# MIDTOWN COLLECTION AT HANNAH RIDGE FILING NO. 2

FILING NO. 2 CONSTRUCTION DRAWINGS

#### Markup Summary 9-9-2019

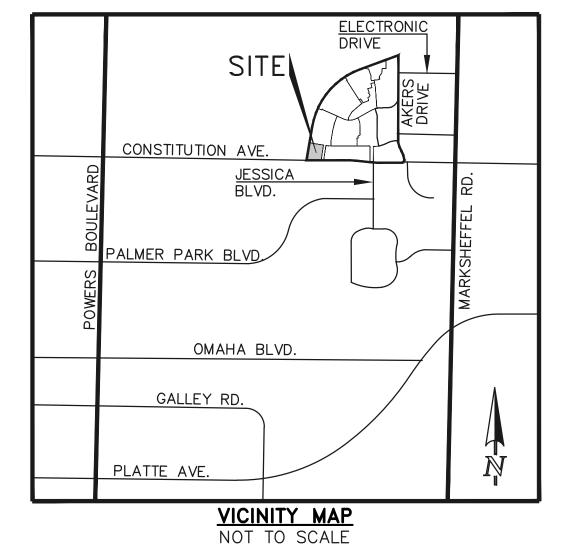
see PUDSP-19-004 comments. 8/21/2019, outstanding comments Address required waiver and deviations for the use of the private streets Pending the PUD Mod. approval; deviations will need to be submitted concerning ntersection spacing and adequate turnarounds,

see PUDSP-19-004 comments. 8/21/2019.

outstanding comment:

Address required waiver and deviations for the use

of the private streets.

Pending the PUD Mod. approval; deviations will need to be submitted concerning intersection spacing and adequate turnarounds,

FILING NO. 2 OVERLOT GRADING AND EROSION CONTROL PLAN

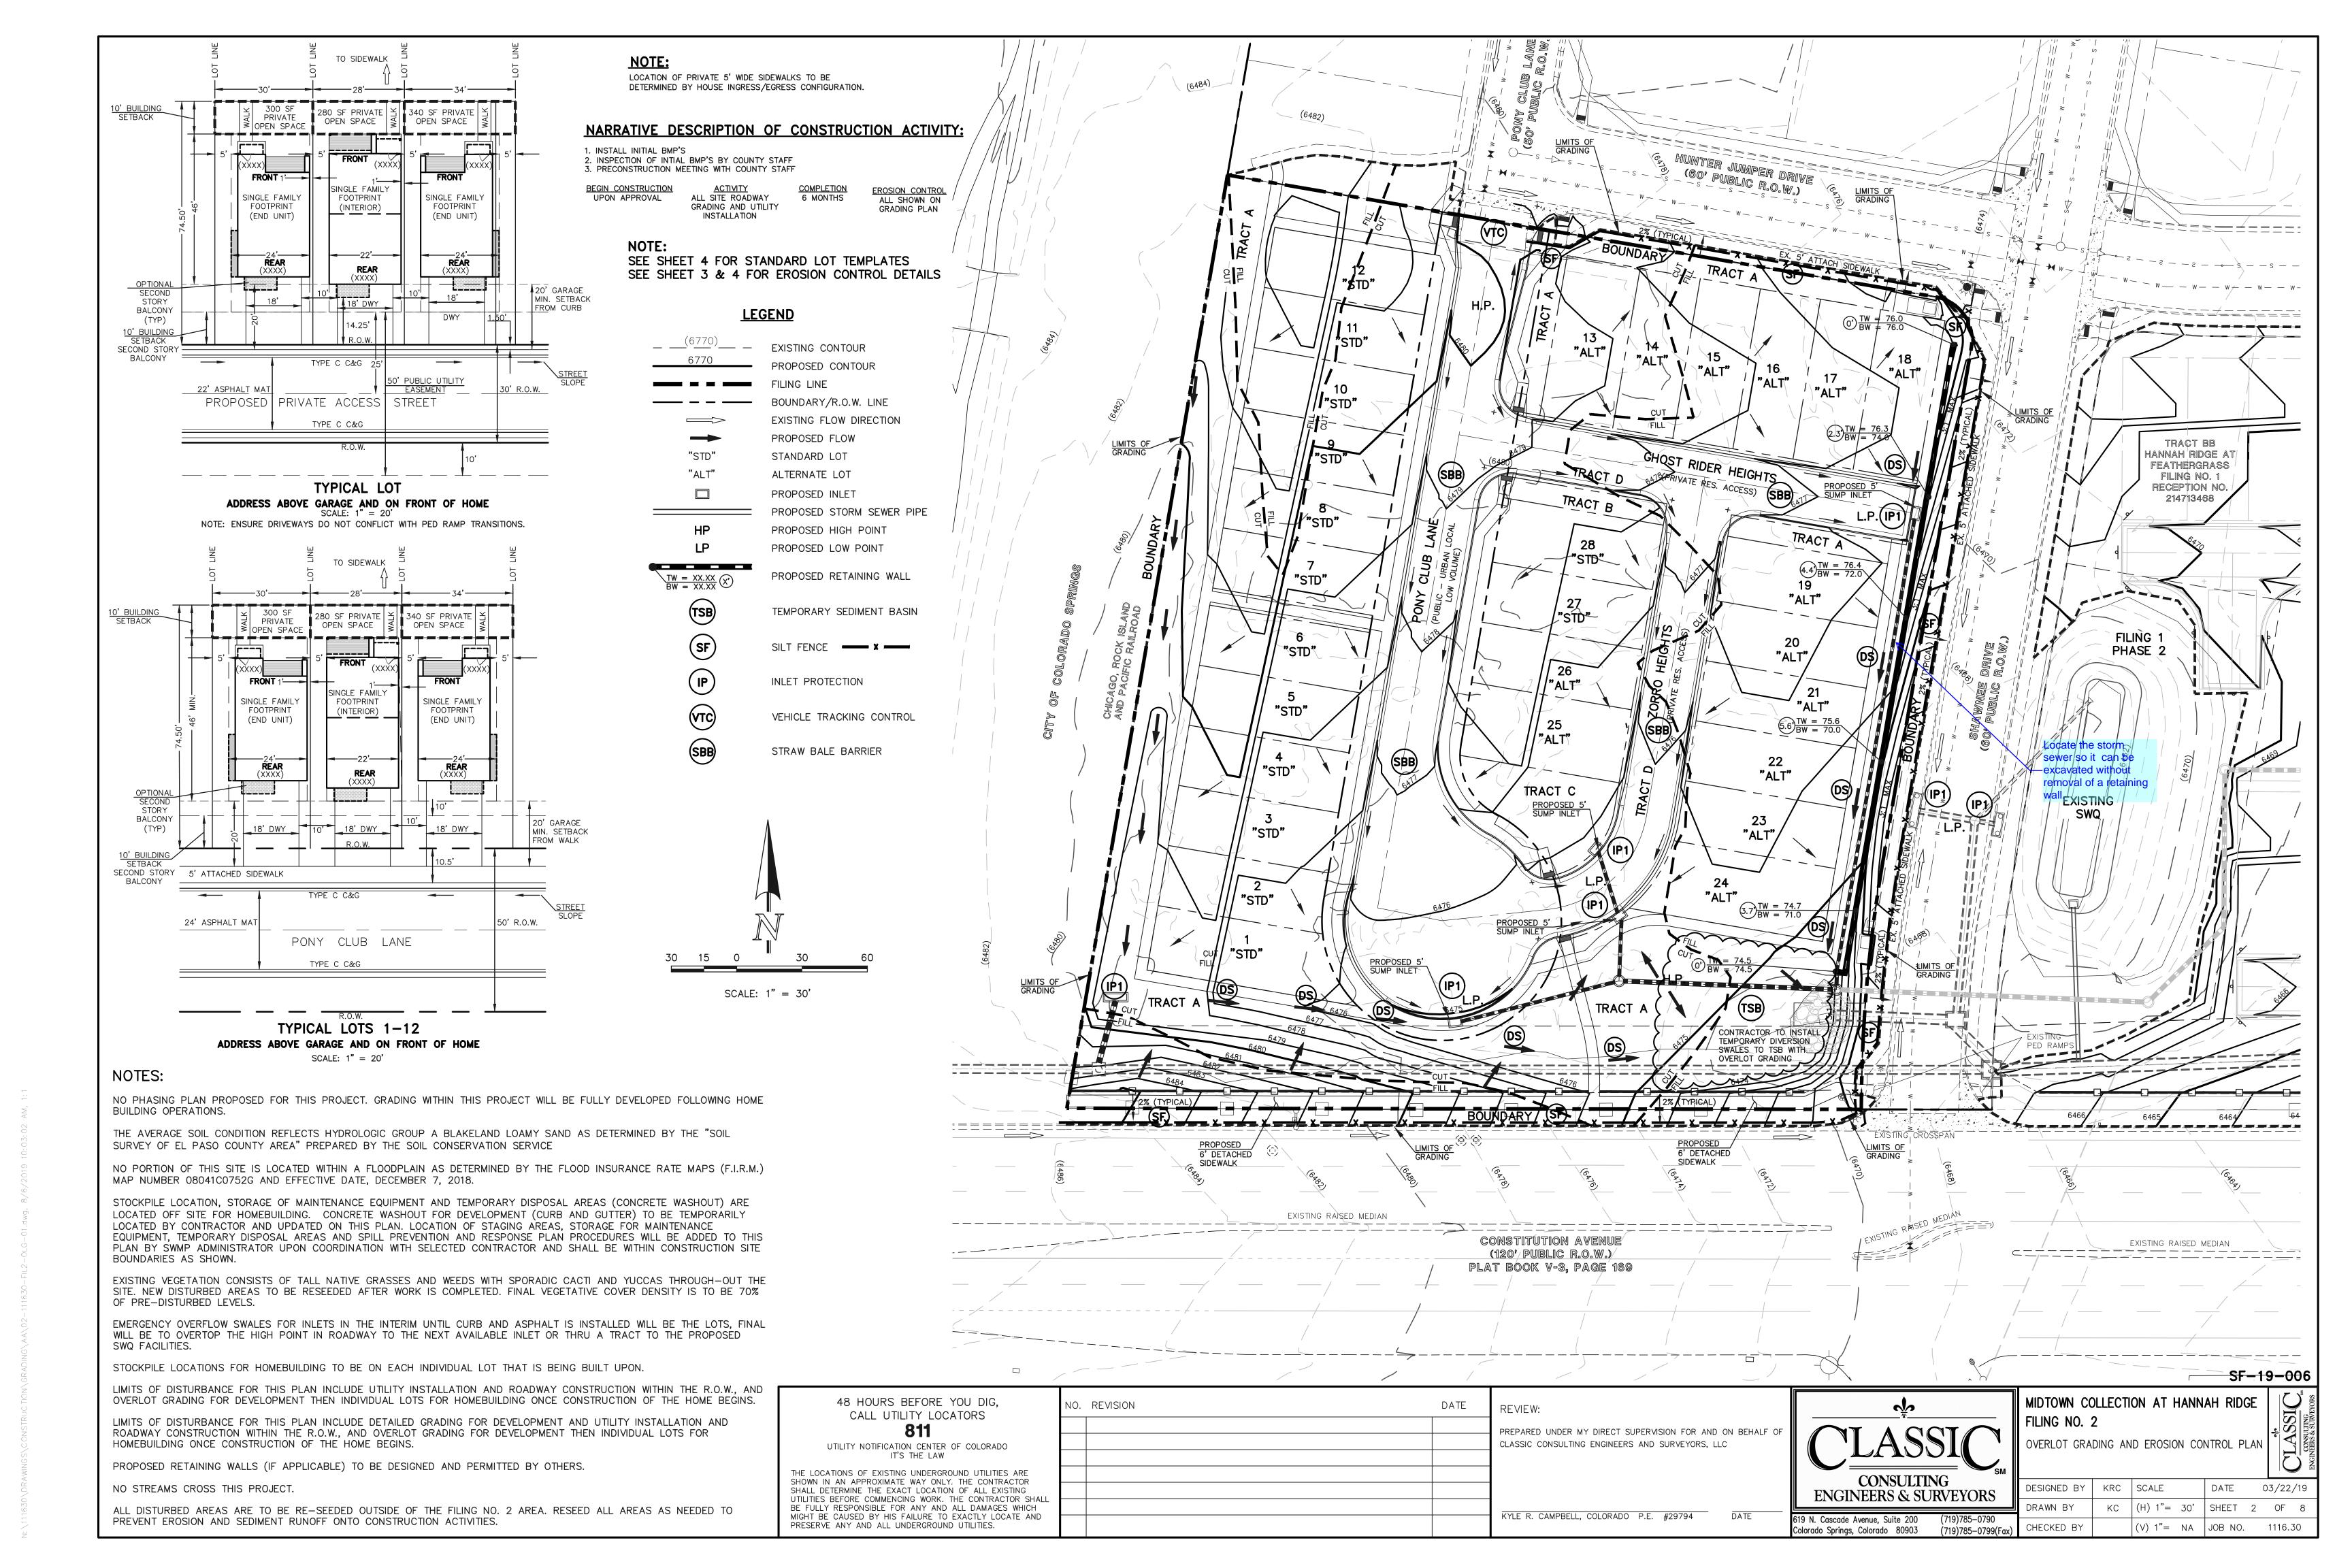
Locate the storm sewer so it can be excavated without removal of a retaining wall.

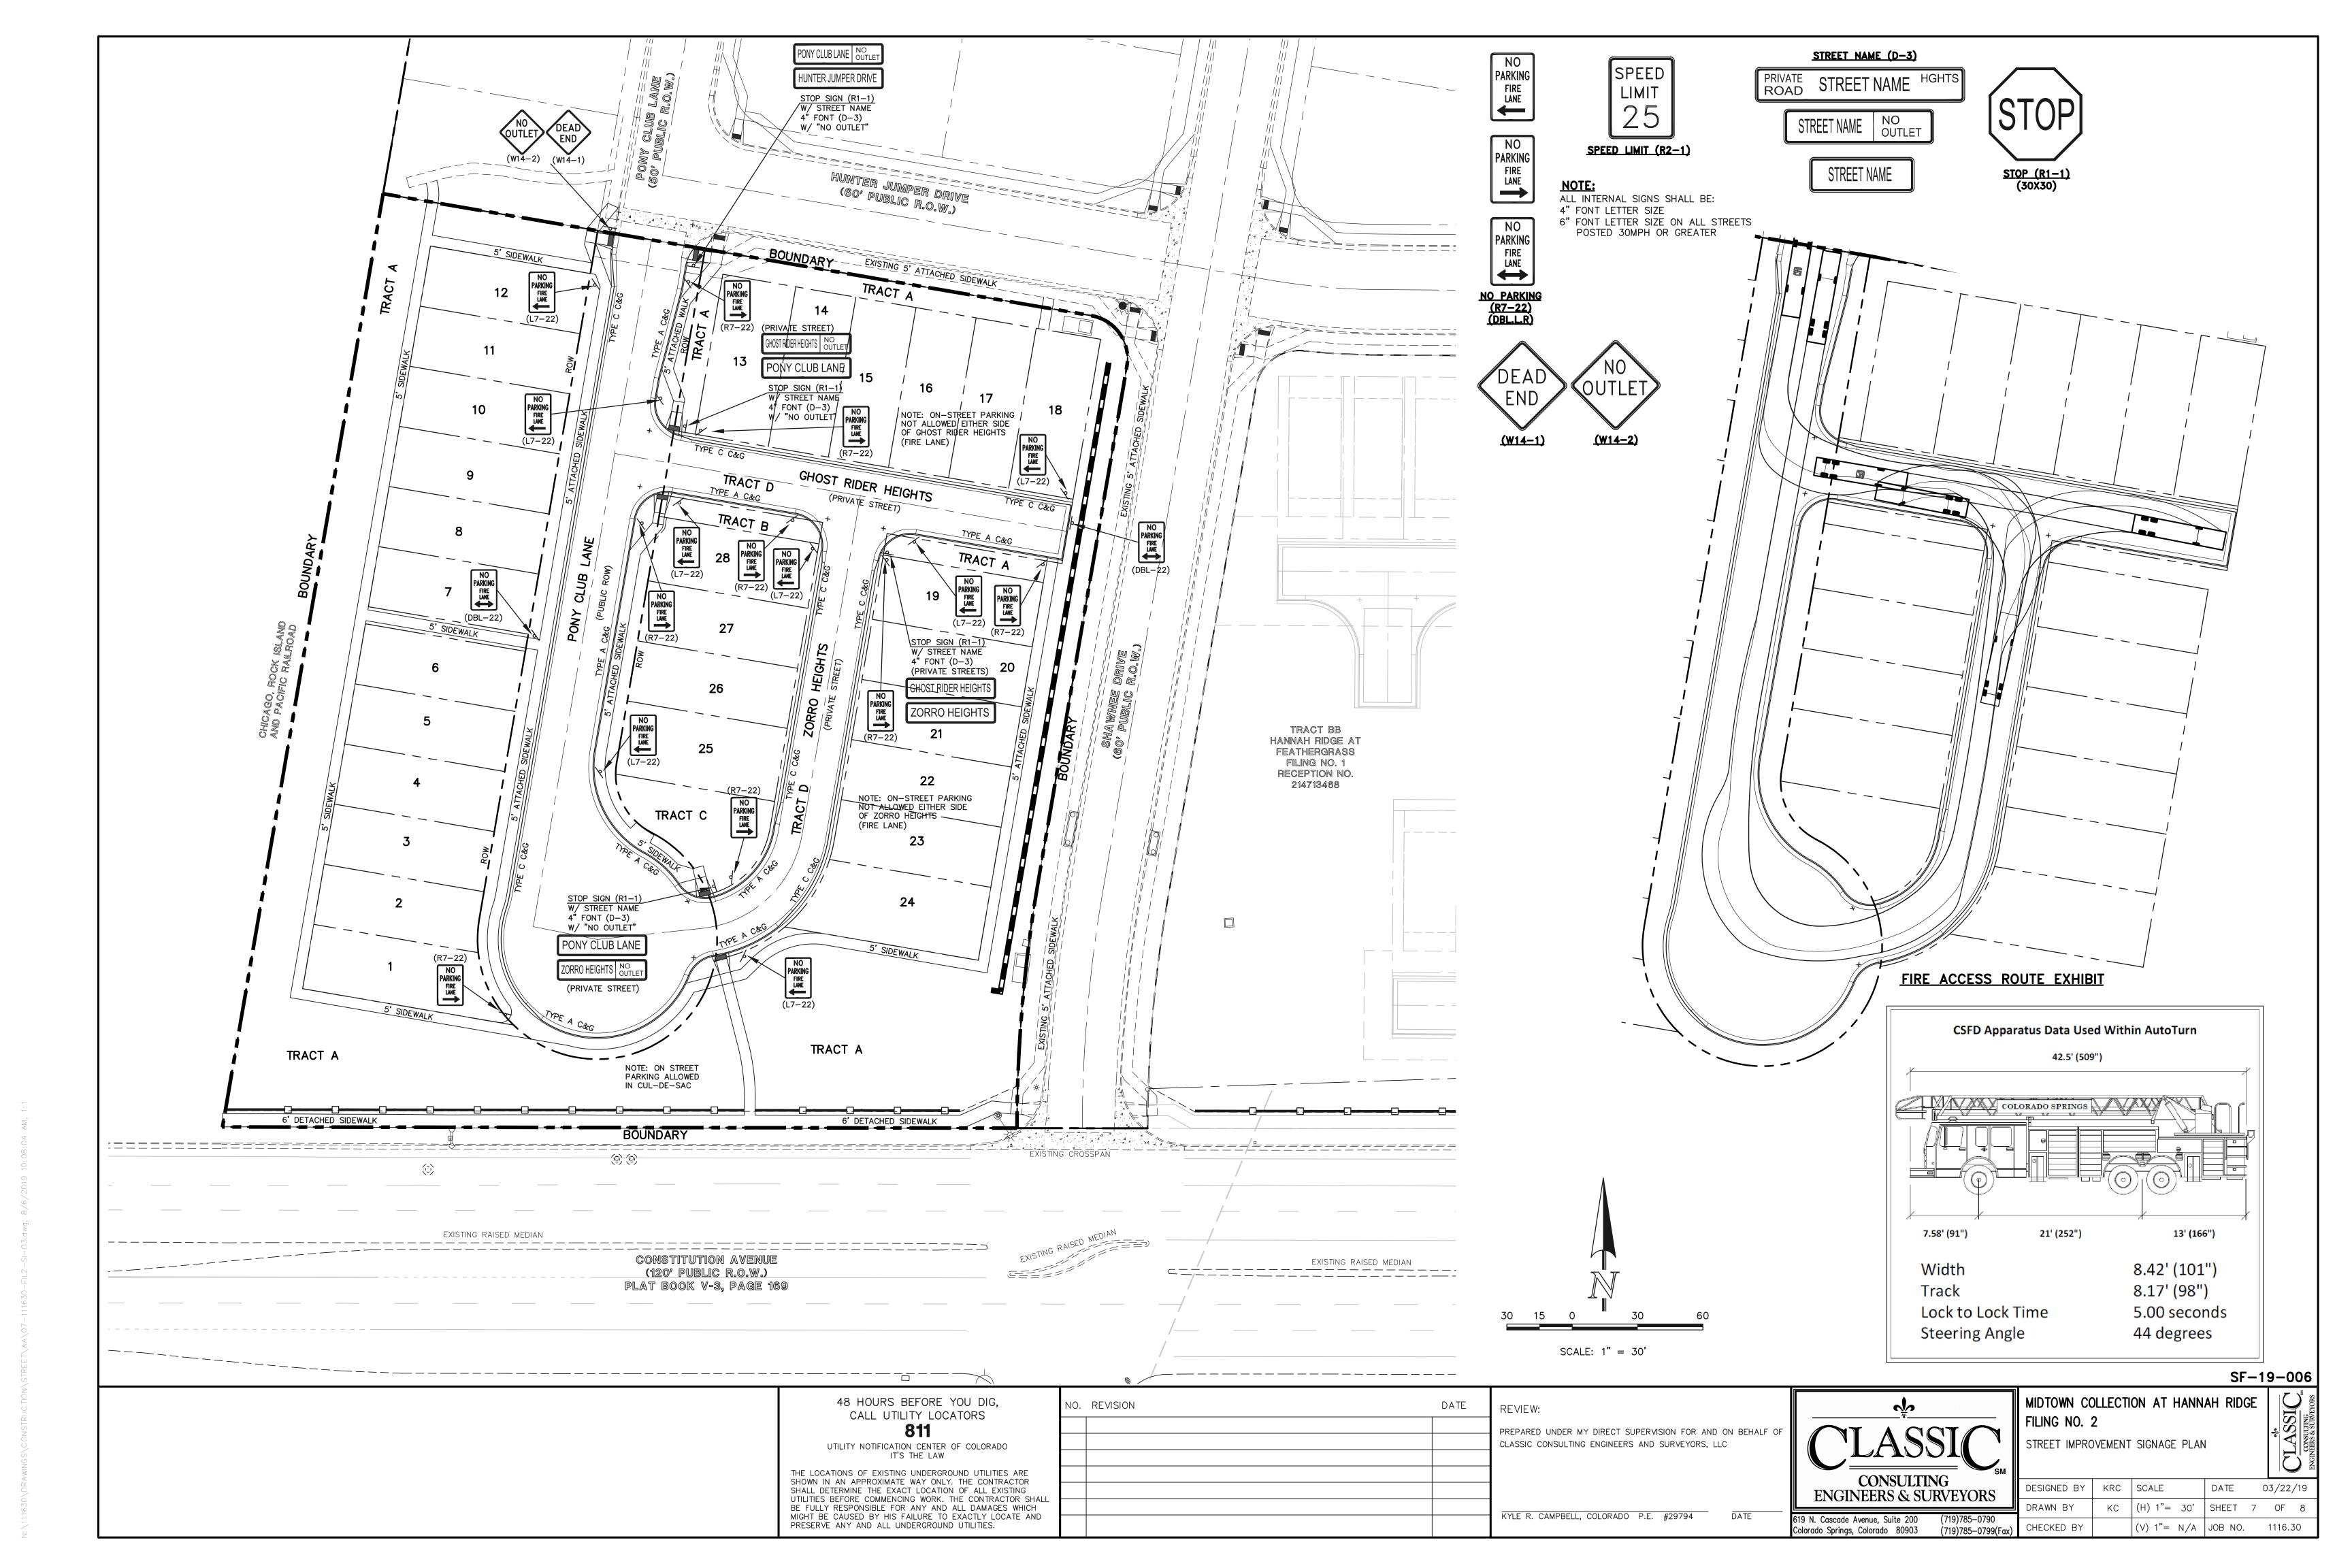
Recommend the location of this pipe run be modified so it can be replaced/repaired without having to remove the retaining wall. Provide an exhibit that shows how this will be accomplished. a transverse section that shows the retaining wall,

sidewalk, fence, trees etc.
